UPDATE Technical Bulletin

SB-10057052-3819

UPDATE – 55i3 Fuel Door (NVLW)

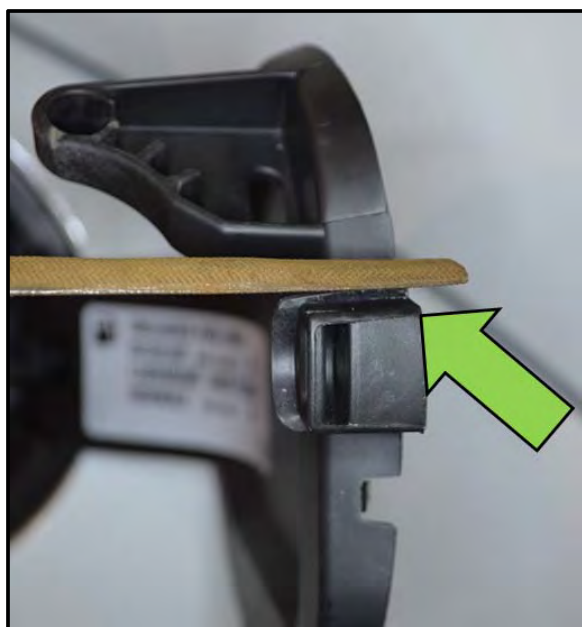
- ⇐ Use a Vernier type caliper (or equivalent) to measure the height of the lip as shown <arrow>.
- If the lip is less than 1.7mm high, **Work Complete**
- If the lip is 1.7mm or higher proceed with the rest of this section.

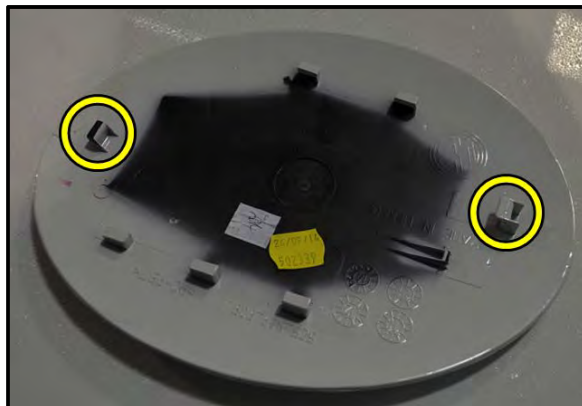
- ⇐ Use a flat file (or equivalent) to file down the lip as shown <arrow>.
- Re-measure the lip as necessary and verify it is shorter than 1.7mm.
- Repeat the filing procedure and re-measure the lip as necessary until it is the proper height.
